SUPPLEMENTAL REPORT TO THE HEARING OFFICER

PROJECT NUMBER: 2019-000010

PROJECT LOCATION: 24937 Mulholland Highway, Calabasas

Re: Response Letter to Cold Creek Community Council (CCCC) to LA County Regional Planning Department
Project No. 2019-000010-(3)

Elisa Paster Managing Partner of RAND PASTER & NELSON, LLP

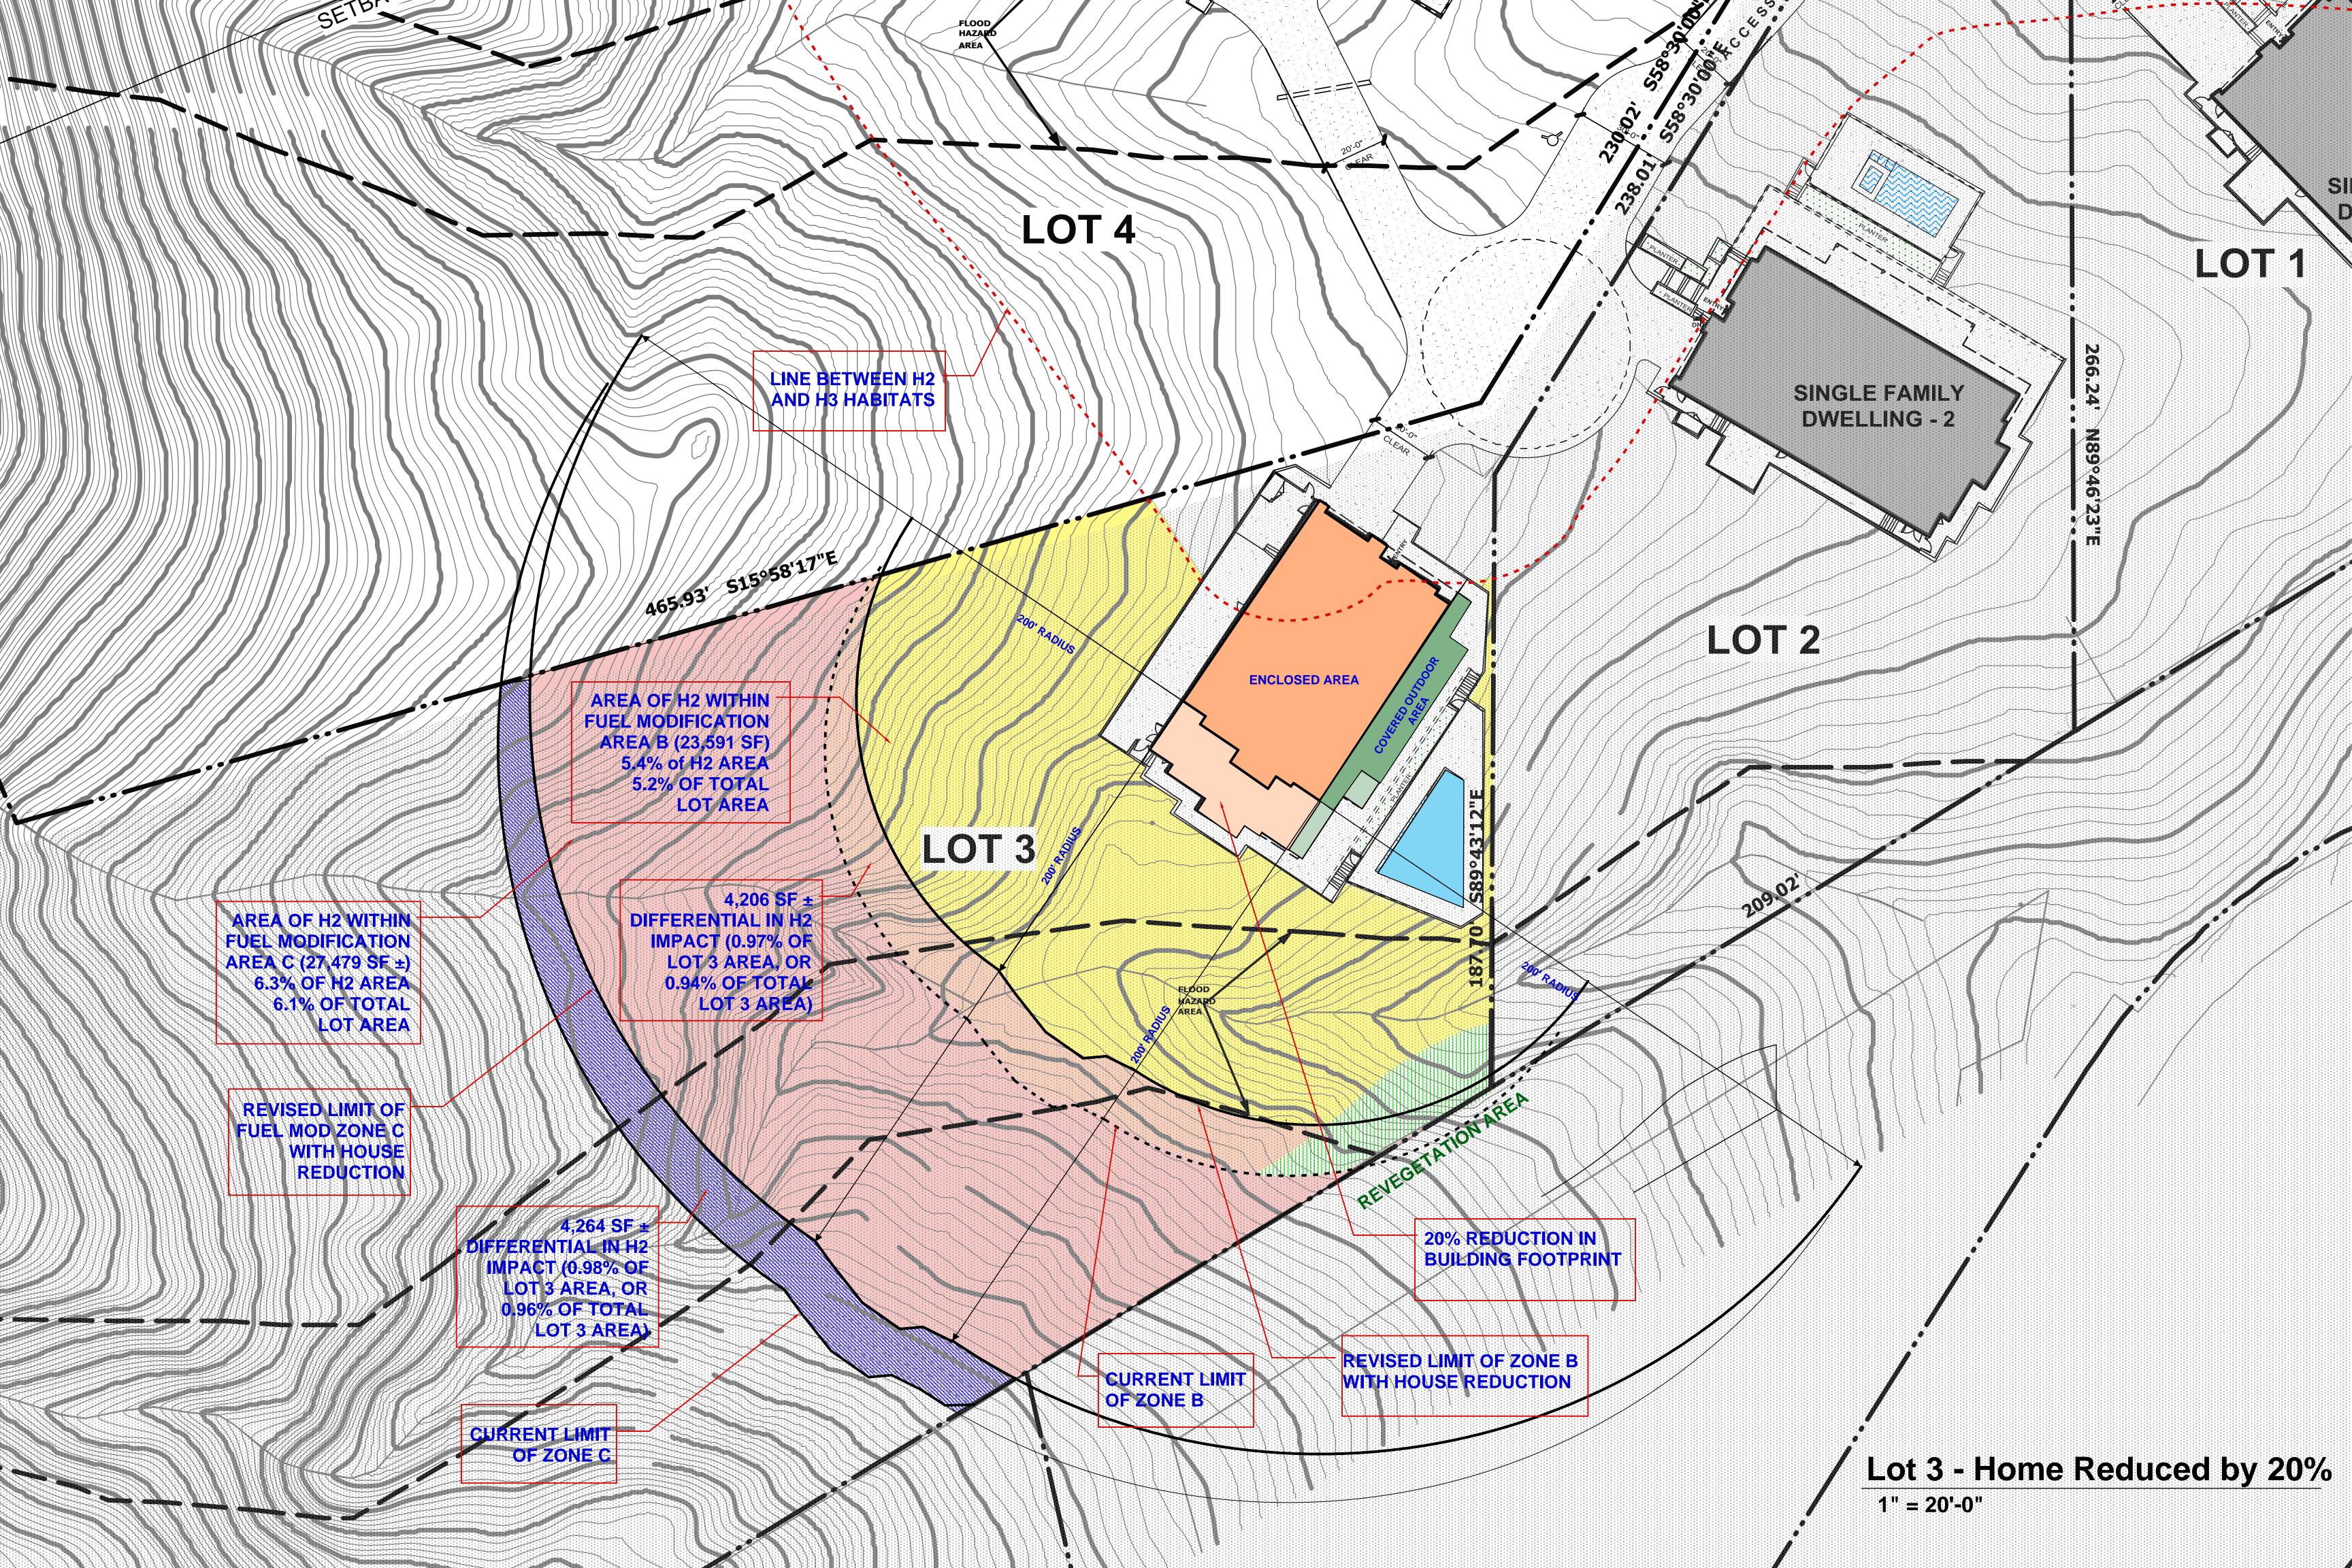
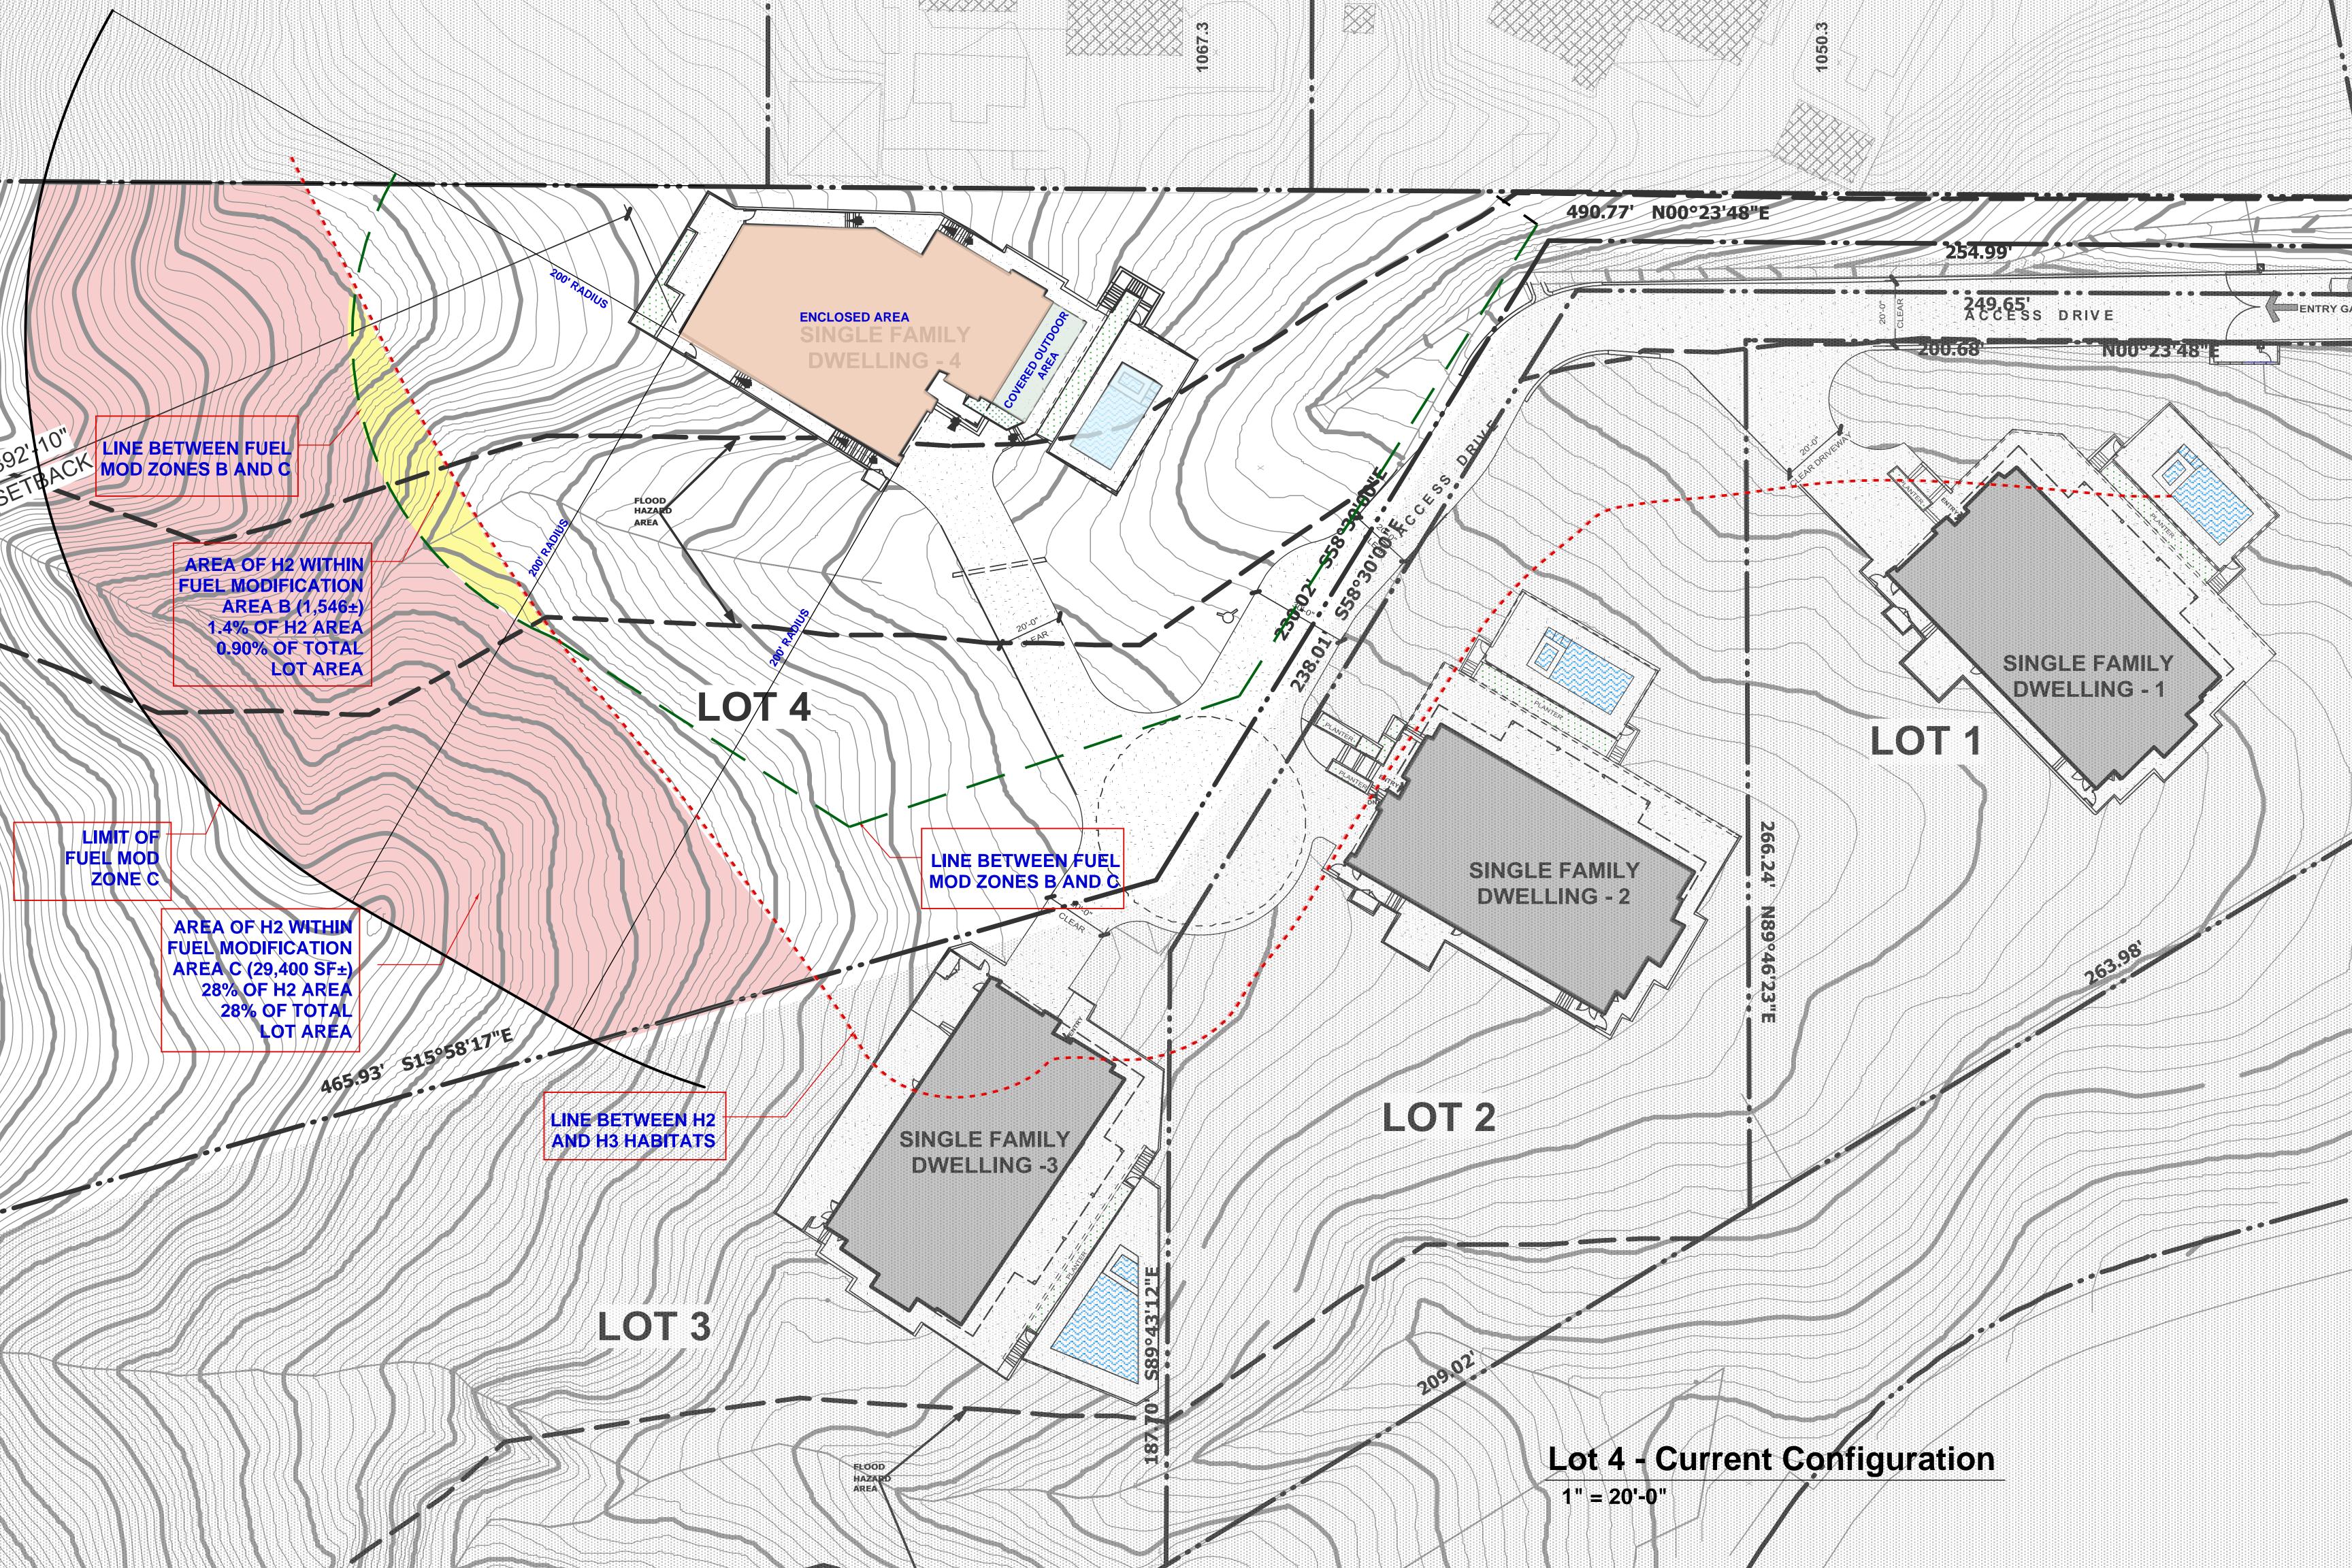
Lot 3 (APN: 4455-019-046): The residence is proposed to be reduced in size by 20% in building footprint at the rear of the building pad, reducing the total size of the residence from 4,114 square feet ("Original Lot 3 Design") to 3,291 square feet ("New Lot 3 Design"). The reduction in footprint greatly impacts the amount of H2 habitat that is preserved and to fuel modification zones B and C. The lot size is 442,134 sf (10.15 acres) and the existing H2 area on Lot 3 is 430,695 sf (9.89 acres).

Lot 4 (APN: 4455-019-047): The residence is proposed to be relocated and shifted southward from its originally proposed location while maintaining the same size and therefore reducing impacts to fuel modification zones B and C and reducing the amount of disturbance in the H2 habitat area (5,717 sf differential) from 35 % to 29.5%. The relocation of the residence also minimized impacts to the existing floodplain/hazard area to the west and location and distance to the lot 3 residence. The lot size is 166,934 sf (3.83 acres) and the existing H2 area on Lot 4 is 104,729 sf (2.4 acres).

Original Lot 3 Design	New Lot 3 Design
House Size	4,114 sf	3,291 sf
H2 Habitat Total Affected (sf)	64,096 sf	59,832 sf (4,264 sf
		reduction)
% of H2 Area Impacted	14.5%	13.89%

Original Lot 4 Design	New Lot 4 Design
House Size	4,186 sf	4,186 sf
H2 Habitat Total Affected (sf)	36,663 sf	30,946 sf (5,717 sf
		reduction)
% of H2 Area Impacted	35%	29.5%
